West Newton, East Riding of Yorkshire

For Rathlin Energy (UK) Limited

| Quality Management    |  |                               |  |            |  |  |
|-----------------------|--|-------------------------------|--|------------|--|--|
| Date of Issue         | 20/09/2021   | Report Number                 | JAT2106–REPT–04–R1-Rathlin-WNA-<br>Addendum_EA |            |  |  |

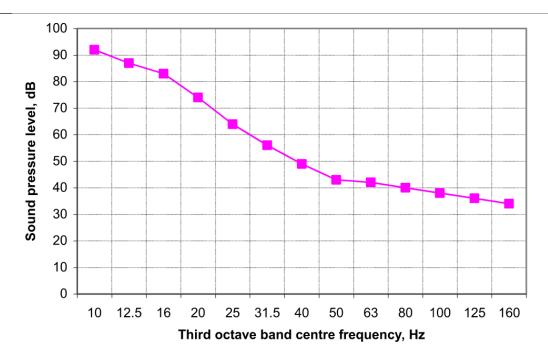
- 2.1 The EA comments requested a noise emissions profile for the generator and associated equipment.
  The EA has also requested an assessment of low frequency noise and tonal noise outputs and impacts and in-detail consideration of mitigation.
- 2.2 For the updated production phase assessment, the following equipment has been assessed:
  - An enclosed flare (incinerator);
  - A Jenbacher JMS 624 GS-N.L generator;
  - 8 x Beam pumps;
  - A crude oil heater, and
  - A transfer pump.

- 2.7 As stated above, at this stage of the project there is no information available on the exact plant models that will be selected. Therefore, the assessment has been based on spectral information on similar plant.
- 2.8 In order to assess the tonality of noise one-third octave band information should be available for the plant as stated in Annex C of BS 4142:2014+A1:2019 "Methods for rating and assessing industrial and commercial sound".
- 2.9 In order to assess low frequency noise at the noise sensitive receptors the procedure indicated in the NANR45 "Procedure for the assessment of low frequency noise complaint" should be followed: The predicted noise levels at the nearest noise sensitive receptors in one-third octave bands should be compared to the criterion curve shown in Figure 1 of the NANR45 which is reproduced below.

- 2.10 At this stage of the project the one-third octave band information and information down to 10 Hz is not available, therefore it is not possible to assess the plant for tonality or assess the low frequency noise at the noise sensitive receptors. Therefore, a qualitative assessment of the tonal and low frequency noise has been undertaken.

- 2.11 Based on experience from similar plant types the enclosed flare (incinerator), beam pumps, crude oil heater, transfer pumps and generator aggregate are not expected to contain any significant tones or low frequency noise. The generator exhaust might contain tones at lower frequencies; however, this is dependent on the exact type of generator that will be selected during the design stage.

- 2.12 As a conclusion it expected that the proposed equipment is not expected to be tonal or emit low frequency noise. However, this is subject to verification during the detailed design of the development.
